## Right-Sized Alternatives to Eversource's planned X-178 115kV line complete rebuild:

Comment to SEC 2024-02 and DE-24-087

kris pastoriza

January 3, 2025

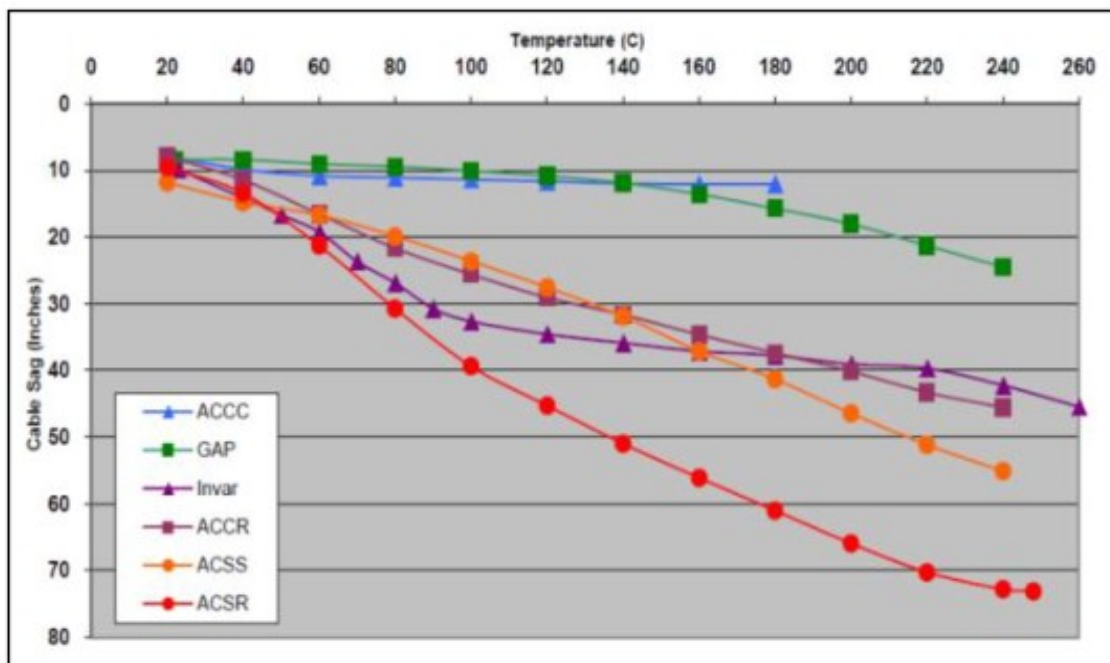
#### **#1:Advanced Conductor**

"Replacing the steel core of the conductor with a carbon fiber composite core makes a big difference. The most used high-performance conductor, the ACCC® (aluminum-conductor-composite-core) conductor, has a hybrid carbon fiber core and trapezoidal profile for the aluminum strands, allowing almost 28 % more aluminum without any diameter or weight penalty. It basically doubles the "ampacity", the power transfer capability, while at the same time reducing the line losses by 25-40 %. The thermal expansion is about 1/10 compared to an ACSR conductor.

The lower thermal expansion is a big deal, when it comes to sags, but even more important is the radically different characteristic in terms of sags as a function of temperature. For the ACSR conductor the sag is proportional to the temperature of the conductor. For the **ACCC**<sup>®</sup> conductor the sag is proportional to the temperature but only up to a “knee point temperature”. Above that point the sag basically remains constant! It substantially reduces the risk for tree-to-line contacts at overloads.

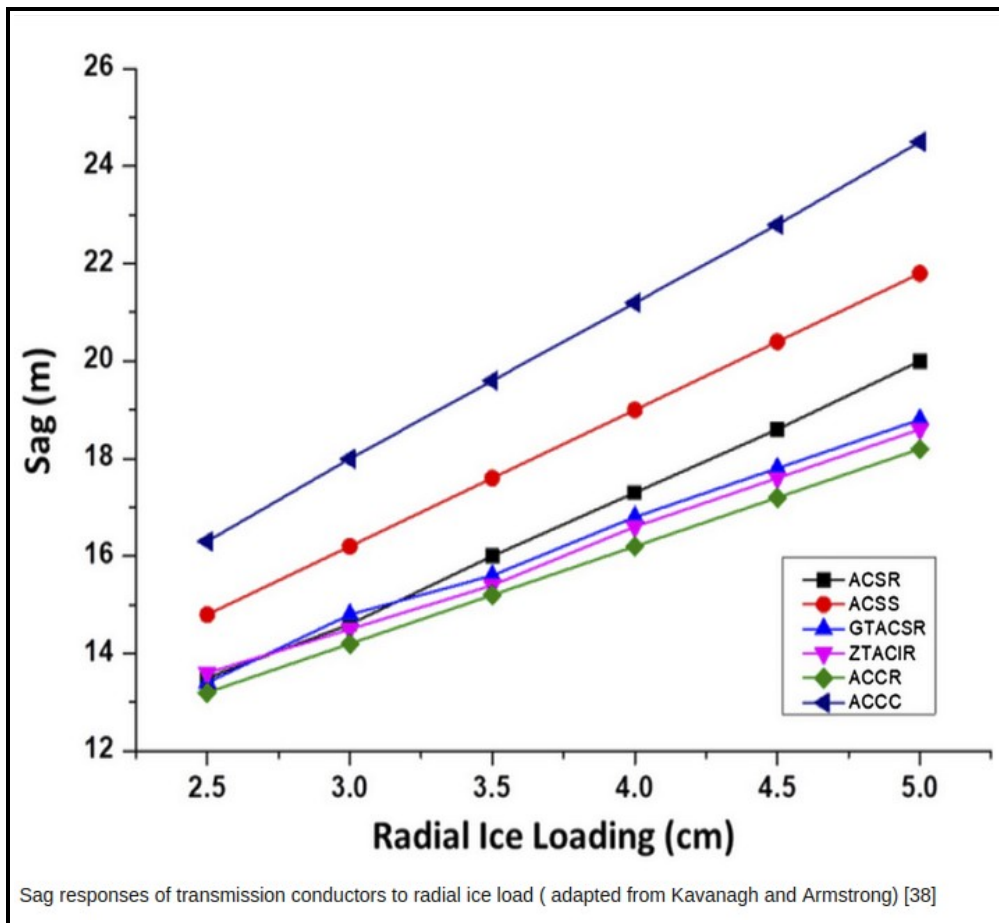
At the October PAC presentation Chris Soderman said that ACCC conductor would not work on the X-178 because it experienced the greatest sag with ice loading, not heat, and under ice load would not have (at what size?) less sag than the 1272 ACSS.

He appears to have been incorrect. The graph below compares conductors and though it does not indicate if they are of similar max amperage or similar size, or the span, the sag of the ACCC type conductor under 1” of radial ice is less than that of ACSS.

Since Eversource is moving all the structures it is not clear why it does not consider using the ACCC with longer spans where its qualities would be used to best advantage.
